Docket Item # 17
BAR CASE # 2007-0198

BAR Meeting
October 3, 2007

ISSUE: Addition and alterations
APPLICANT: James & Judith Blaha
LOCATION: 722 S. Royal Street
ZONE: RM/Residential

Figure 1: proposed east elevation

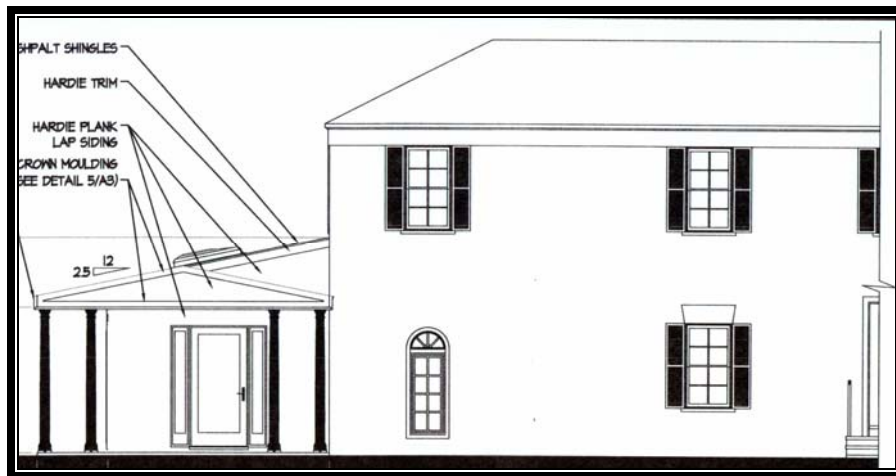
Staff has no major objections to the proposed addition and believes that it complies with the *Design Guidelines* for residential additions. It is modest in size and will not be readily visible from the public right-of-way. A number of features of the addition, such as the domed skylights, vinyl clad windows and door and fiberglass columns would not be acceptable if they were in a more visually prominent location. The skylights are not expected to be visible from the public right-of-way. As discussed above, the north side of the addition will be minimally visible. The addition is set back at least 45' from the public-right-of-way. For this reason and because they are part of a new construction project, Staff is willing to accept the vinyl clad windows and door and fiber glass columns on this elevation, although wood is preferable. With respect to the use of fiber cement siding, the Board has adopted the following policy:

The use of fiber cement siding is appropriate in this case as it is to be used on a new addition. The applicant has specified that the siding will have a smooth finish. Staff notes that, in accordance with the policy, item #4, the nails must not show in the installation of the siding.

1. That the Hardiplank siding be installed so that the nails do not show; and,

Figure 2: proposed north elevation

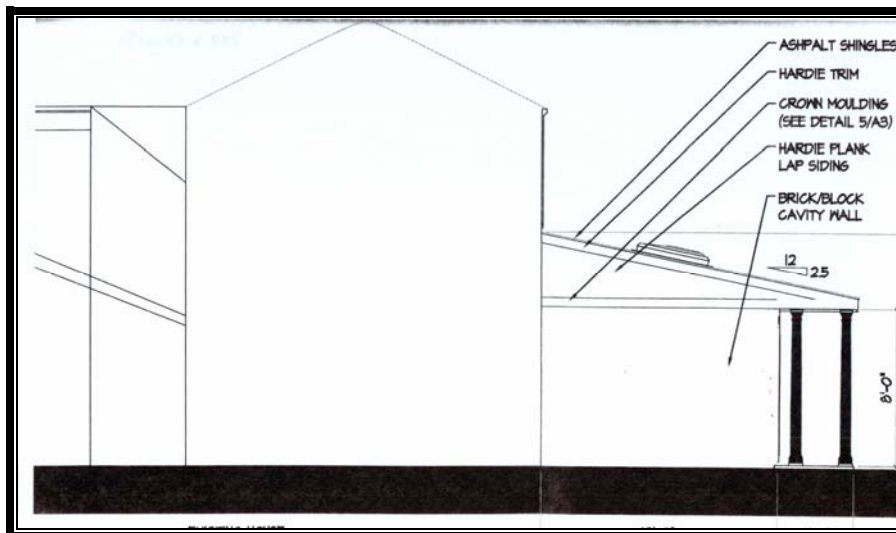
Much of the addition will not be visible from the public right-of-way as the mid-block house is landlocked. However, it is an end unit and the north wall of the existing house is visible from the street through the narrow side yards of the both 722 and 720 South Royal Street. The north side wall of the addition may be visible in a distant and oblique view. The north side porch, which projects 4' out from the north wall plane, is expected to be visible, although at some
